BF24-T & BF230-T UPGRADED WITH BF24-TN & BF24-TN

The BF24-T & BF230-T fire/smoke actuators have now been superseded by the:-BF24-TN & BF230-TN

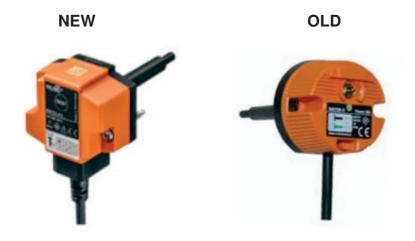
The only changes between the old and new products is the shape and test operation of the built in thermal fuse.

The old BF24-T & BF230-T actuators have a round fuse housing and a toggle switch to enable testing of the actuator.

The New BF24-TN & BF230-TN actuators have squarer shape housing and a push button to enable testing of the actuator.

All other aspects and functions of the BF actuators remains the same.
